MEMORANDUM – MANDATORY REFERRAL

SUBJECT: Mandatory Referral No. 06601-MCPS-1: Sherwood High School Addition –
300 Olney-Sandy Spring Road (MD 108), Sandy Spring/ Ashton Master Plan

STAFF RECOMMENDATION: Approval with the following comments to be transmitted to Montgomery County Public Schools (MCPS):

Proposed Site Plan

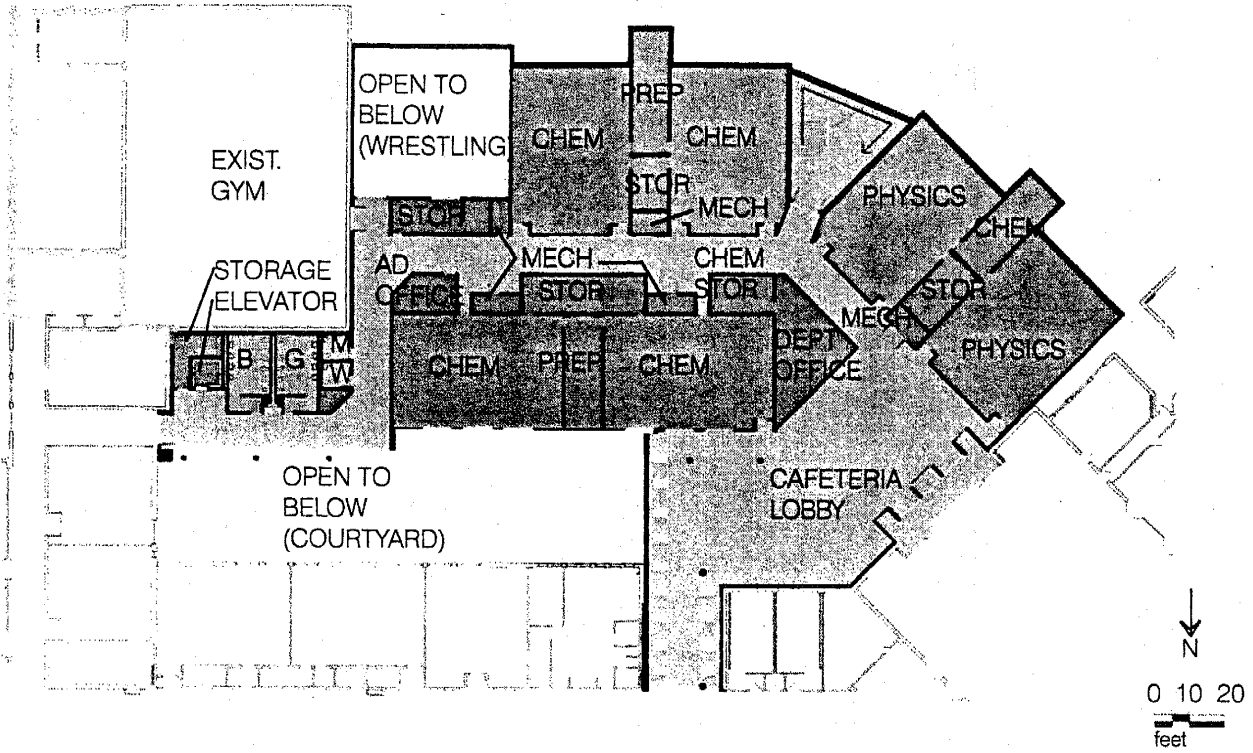
1. Provide a traffic study for the school in the event that the proposed enrollment exceeds the current enrollment of 2,241 students.
2. Reduce the width of the pathway leading to the greenhouse to 12 feet and provide removable bollards at the start of the pathway to limit vehicular use.
3. Prior to the approval of the final sediment control/stormwater management plan by the Department of Permitting Services (DPS), submit a final Tree Save Plan for Environmental Planning staff review and approval showing the final limits of disturbance including all improvements to the existing stormwater pond, demonstrating no disturbance to forest in the environmental buffer.
4. The project is encouraged to use sustainable building design techniques in accordance with the U.S. Green Building Council on Leadership in Energy and Environmental Design (LEED).

The 16-classroom addition is intended to replace the existing 8 relocatable classrooms that are located in an area between the perimeter road and the stadium, and to make other internal improvements to the school building. This project will add a two-story addition to the southwest side of the school building, in an area where the existing greenhouse is located. The addition will include: 16 classrooms, a cafeteria extension, an additional elevator for increased accessibility, renovation of the Food Nutrition Science Laboratory, improvements to the school's internal circulation, and a reconfigured section of the school's perimeter road in the area of the proposed addition of the classrooms and core facilities (Attachment 4 includes a list). The existing greenhouse, which also houses the school's horticulture program, will be replaced by a new detached greenhouse that will be reached by a handicap-accessible path from the proposed addition. Staff recommends that the pathway be reduced in width to 12 feet and that removable bollards be installed at the start of the greenhouse pathway to limit vehicular use.
